Access Compliance Report

Public Rights-of-Way

| Intersection ID: 30010 | Main Street: BACKWATER_DR | Cross Street: SMOOTHSTONE_LN | Location: SE |
| ADA ID: 7790B02F52F9 | Ramp Type: PerpDiag | Initial Pass/Fail: Fail | Overall Compliance: No |

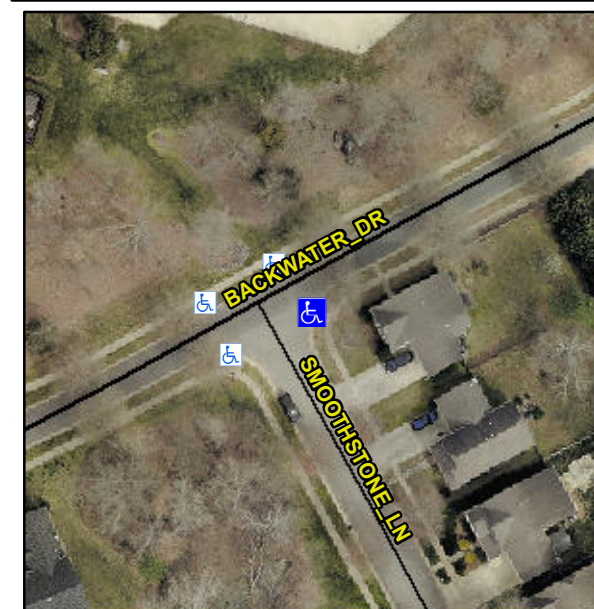
Not Found, R304.5.1, R304.5.3

| Compliance | Description | Data | Compliance | Description | Data |
|------------|-----------------------|------|------------|-----------------------------|------|
| N/A | Ramp Length (in) | 75.0 | Yes | Ramp Slope (%) | 7.5 |
| No | Ramp Width (in) | 46.5 | No | Ramp XSlope (%) | 7.3 |

Remove & Replace Curb Ramp With Two New Directional Ramps or Equivalent.
